WASTEWATER IMPROVEMENTS
WINDRUSH TO CARLTON PARKE
MADISON COUNTY, MISSISSIPPI

PWP-05035

DRAWING TITLE
PLAN & PROFILE

PROJECT NO.
596
 CONTRACT SHEET
1

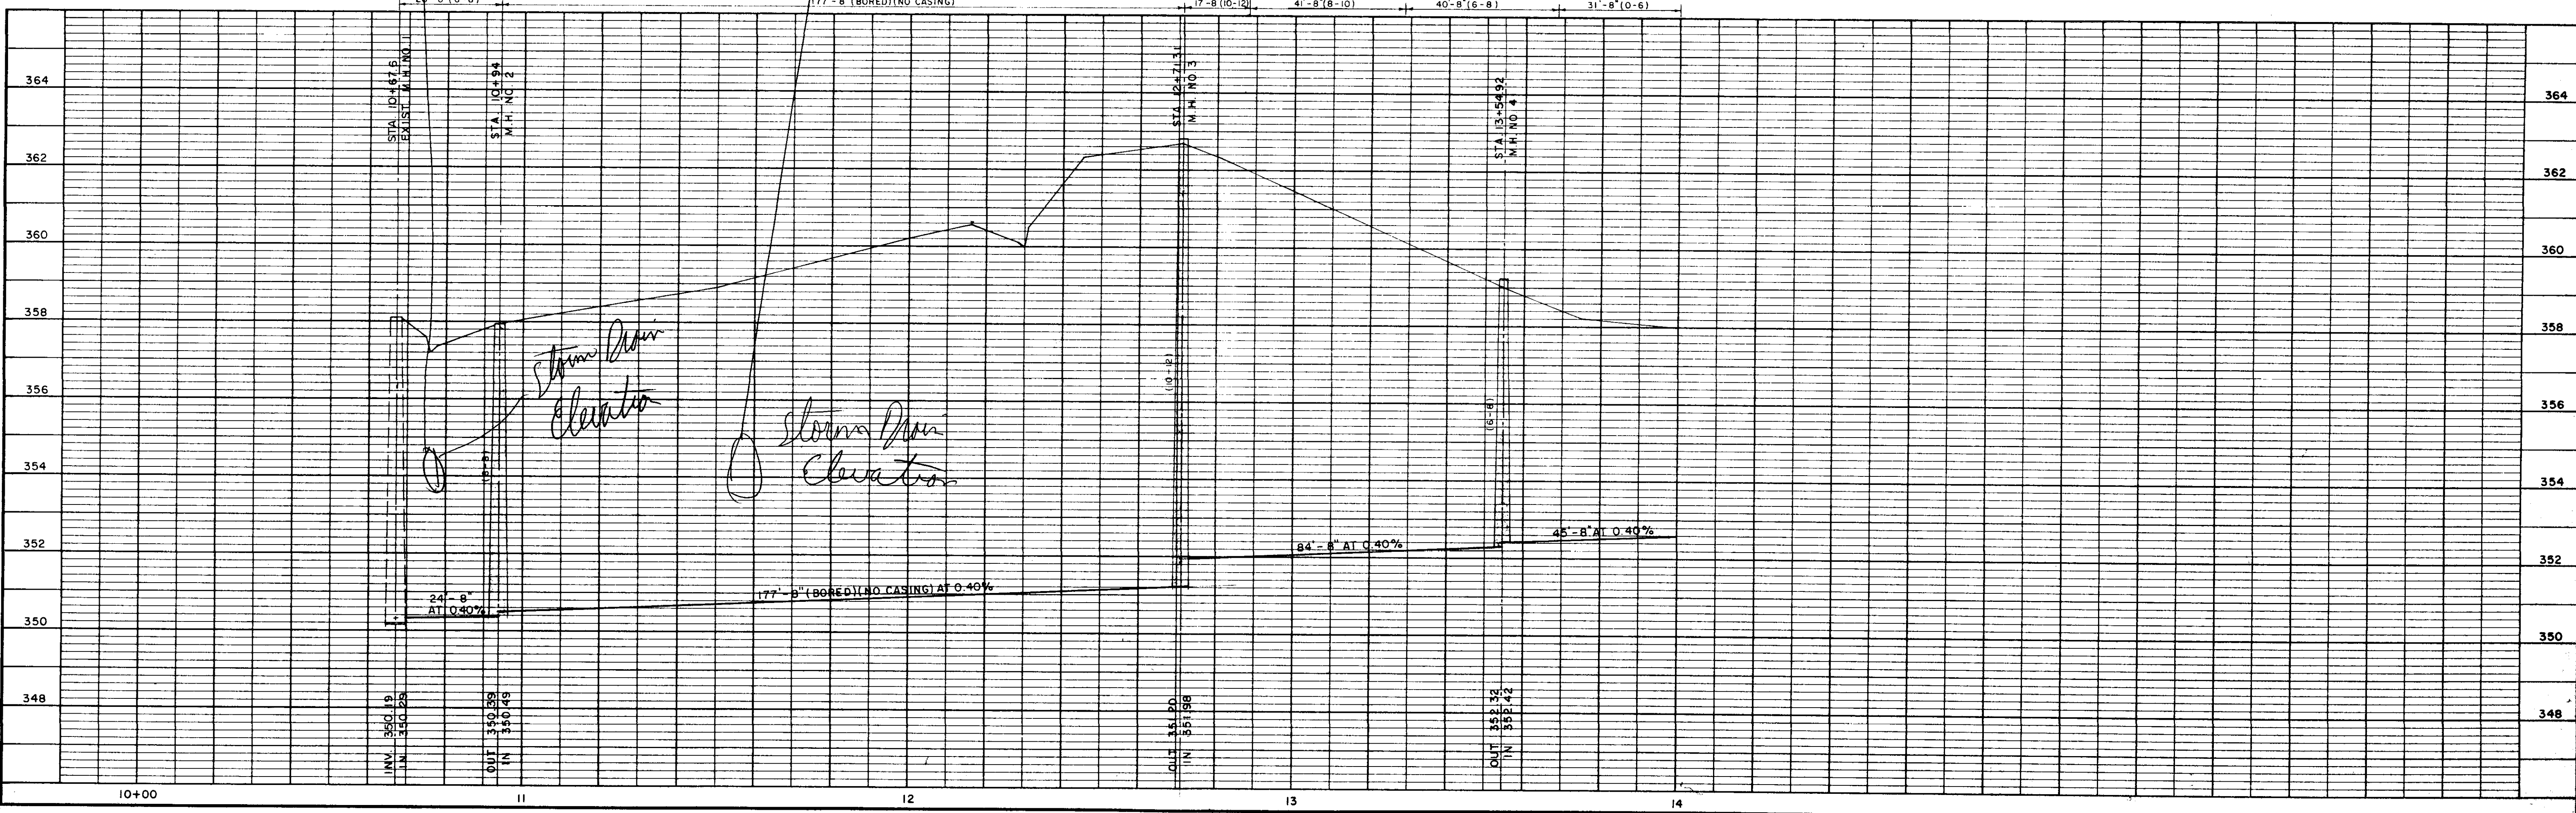
What type of material?

PROJECT NO.
596
CONTRACT SHEET
4

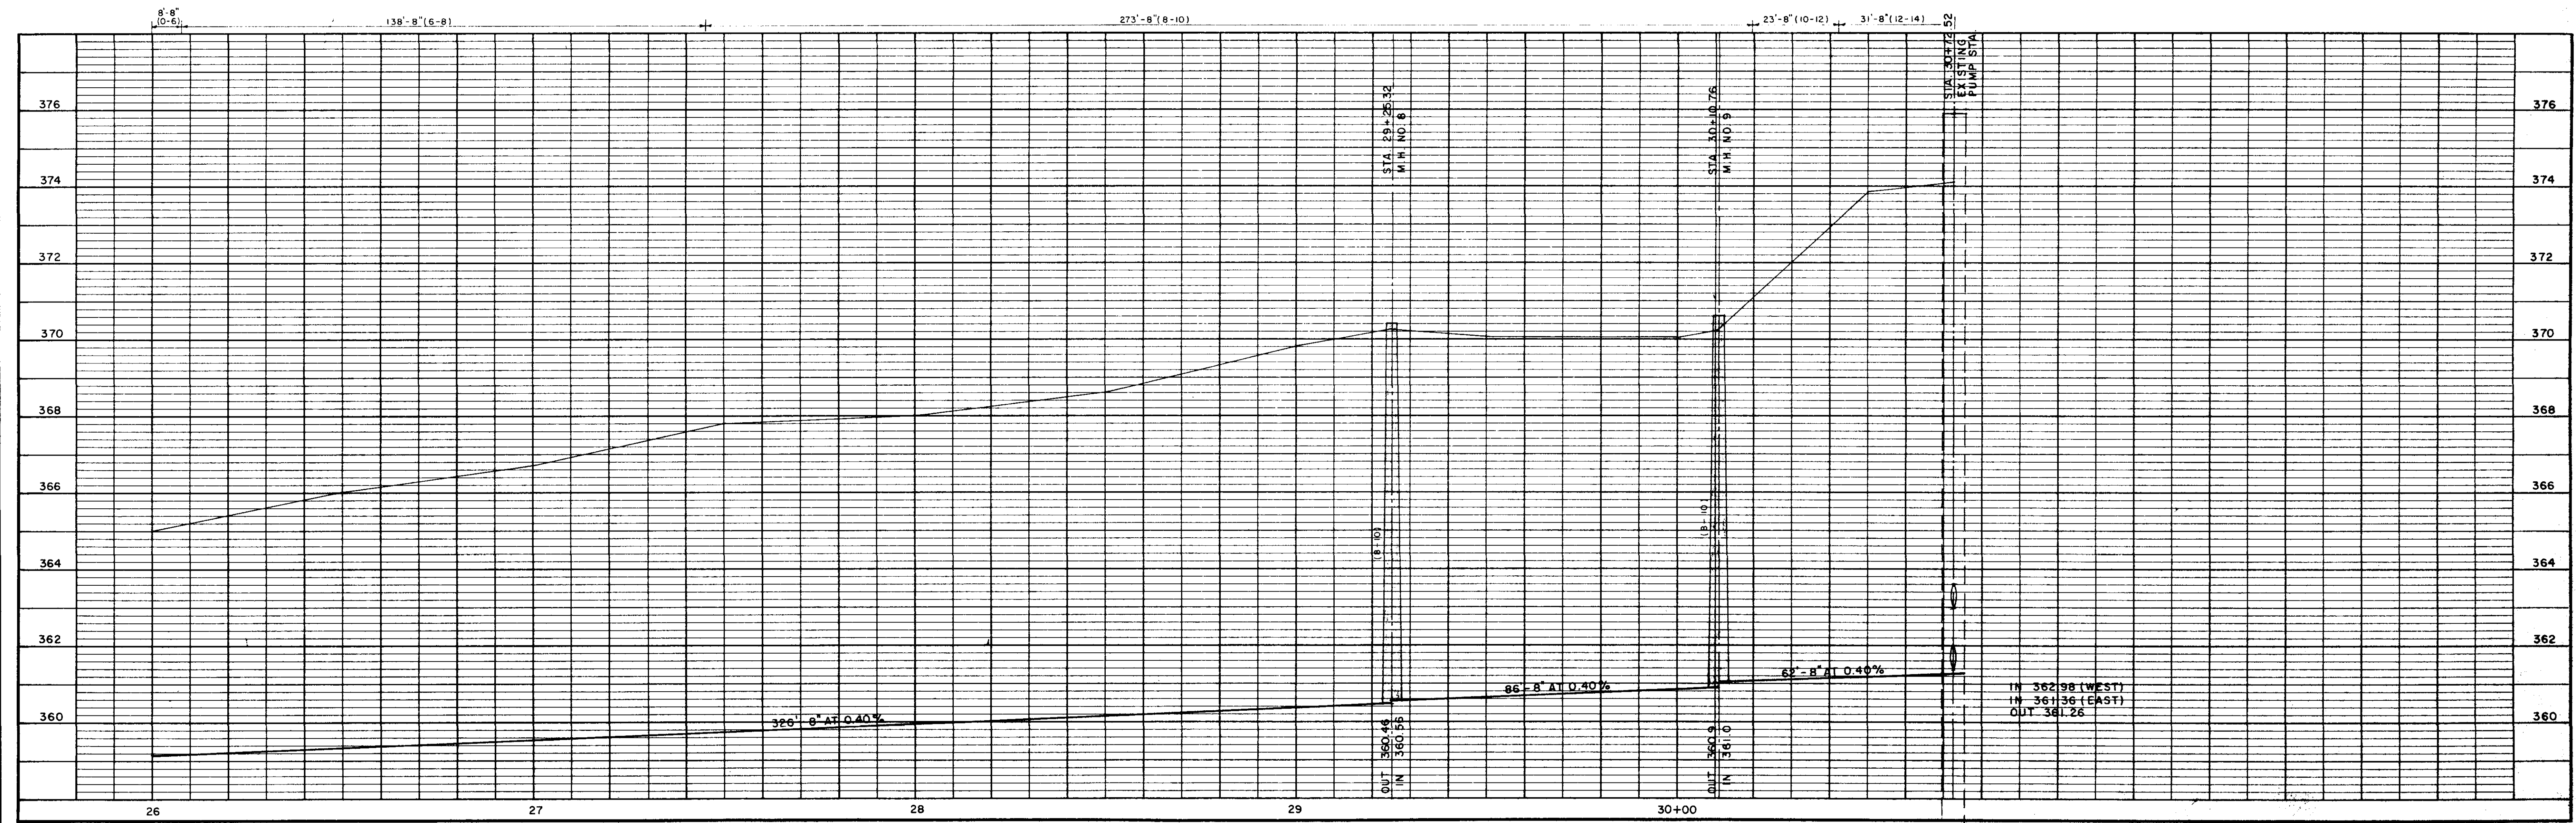
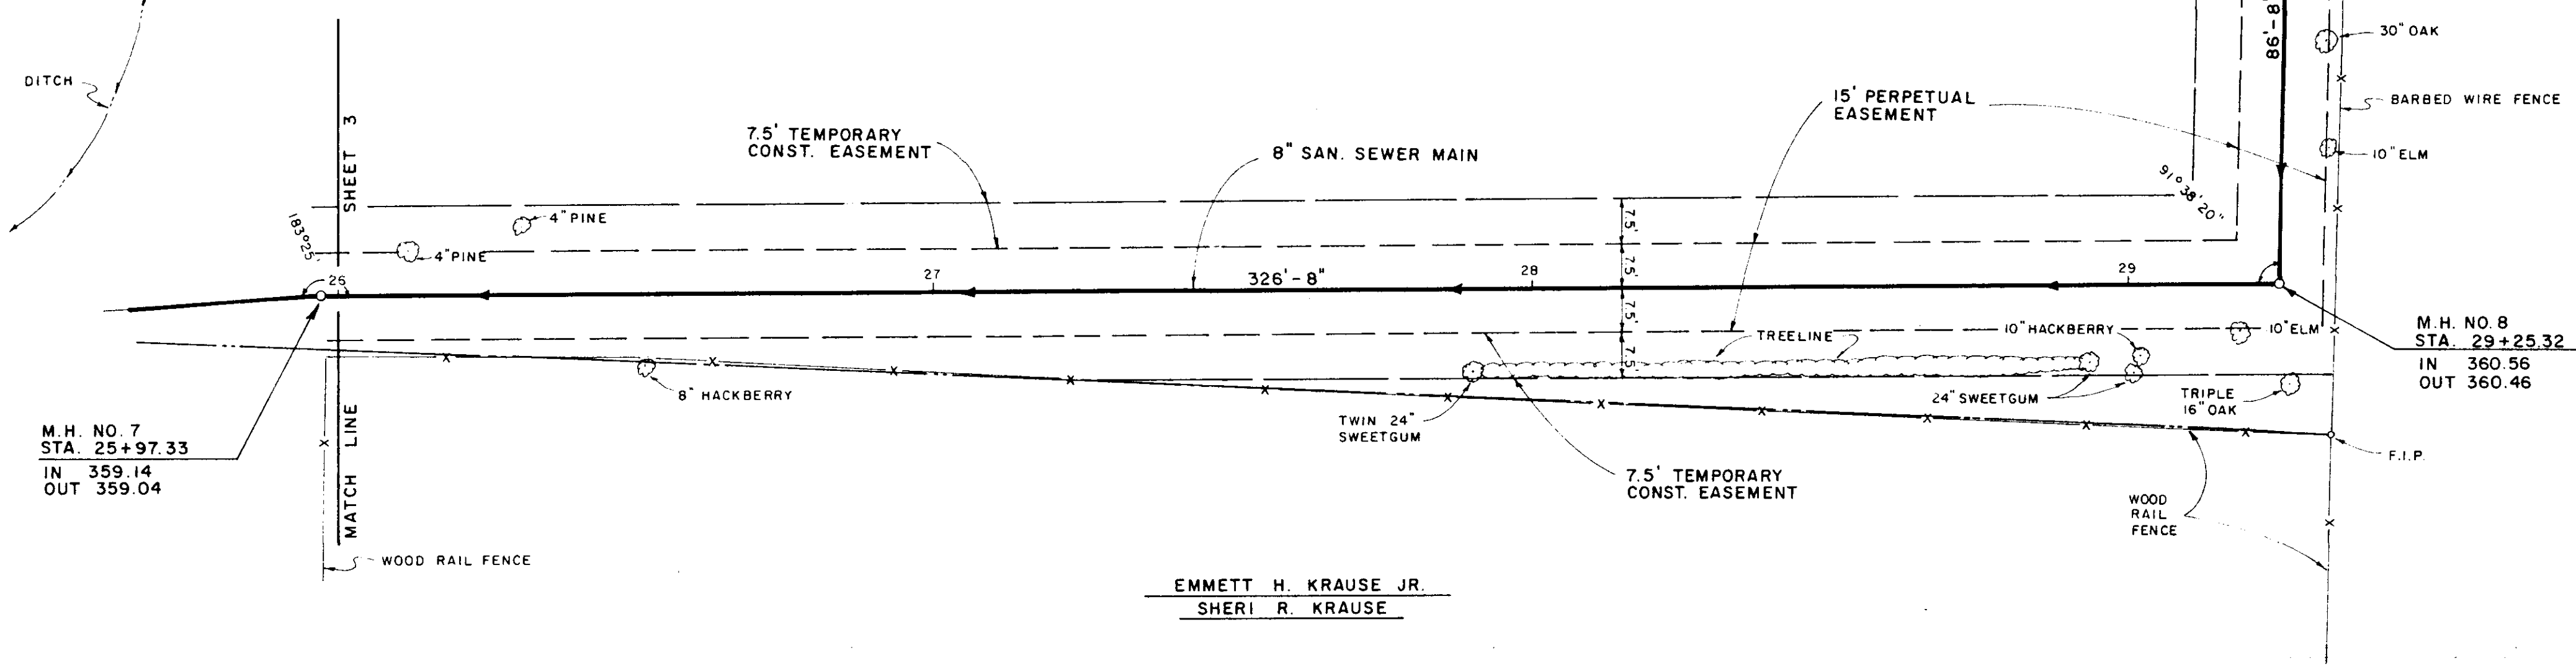
*All Easement
Requires this
Over*
